SP4550000DB Structures Foundations (Design Build)  
COMMENTS FROM INTERNAL/INDUSTRY REVIEW

Comments: (11-1-21, Internal)

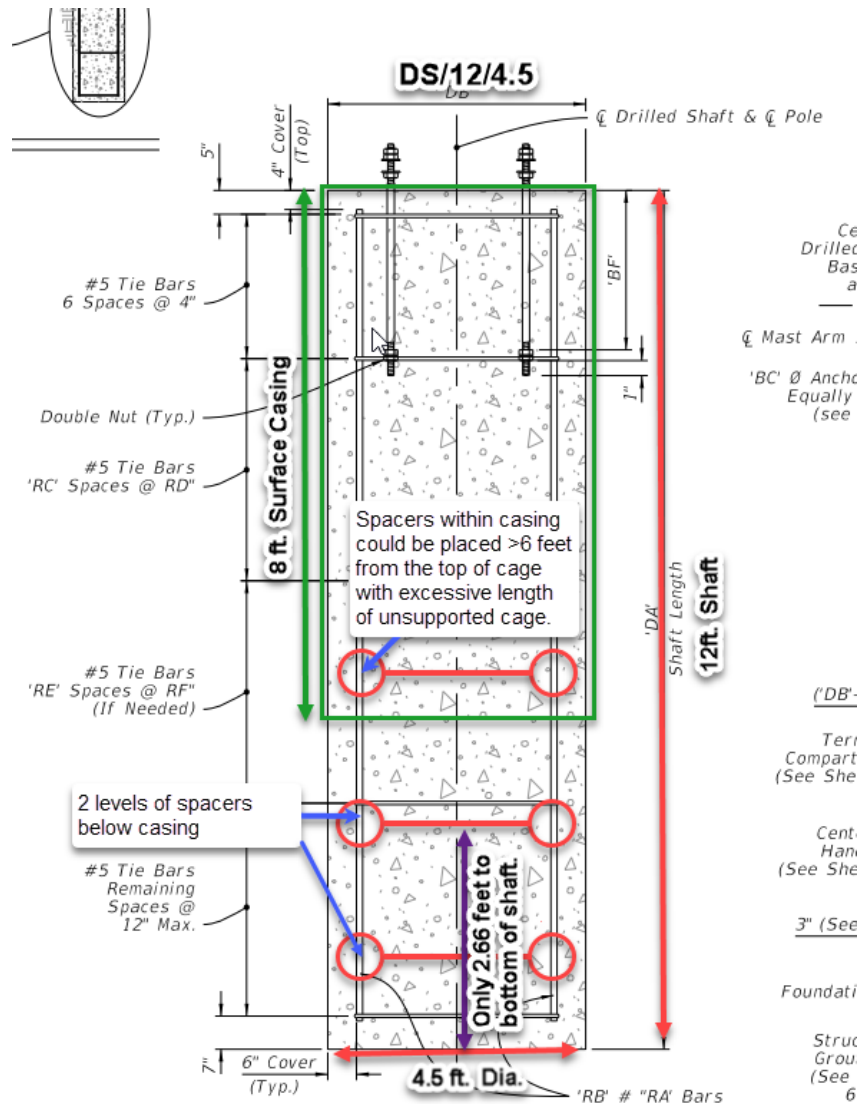
3. The additional table for Mixed Polymer Slurry Properties located within this section, seems to be contradictive to the table in shown in 455-15.8.3 concerning the ranges of viscosities on the miscellaneous structure foundations and the specification language.
  - a. It has been accepted to date that this paragraph is dealing with the testing of polymer slurry, “... *in the shaft prior to placing the concrete,*” 455-15.8.4.

Moreover, the polymer testing requirement of this specification is documented on the construction form 700-010-84 on the Fluid-Slurry sheet under section b) titled, “*Before placing concrete.*” Within these premises, the first paragraph of the specification states, “*When any fluid is present in any drilled shaft excavation, including shafts to support sign, signal, lighting and ITS structures, the applicable test methods and reporting requirements described in 455-15.8.1, 455-15.8.2 and 455-15.8.3 apply to tests of fluid in the shaft prior to placing the concrete.*” The last portion of this specification sentence directs the user to apply the testing ranges listed in section 455-15.8.3. Following this direction back to the last section, the polymer slurry is shown to have a viscosity range of 50 seconds to upper limit recommended by the manufacturer for miscellaneous structure foundations. Whereas, below the opening paragraph in the 455-15.8.4, the user is directed with the following language, “*When polymer slurries are used ensure the properties of the polymer slurry are within the following acceptable ranges at the time of concrete placement.*” The following range for polymer slurry is now listed as 50 seconds to the upper limit defined by APL, which is assumed to apply to all shaft types and is now contradictory to the table in 455-15.8.3: concerning polymer viscosity for miscellaneous structure foundations. **This contradictory question caused the formation of the question below.**

4. Is there a difference in the interpretation of the language of polymer testing in a shaft, “At time of concrete placement,” verses, “prior to placing the concrete,” concerning the utilization of the additional table for polymer slurry testing properties in 455-15.8.4?
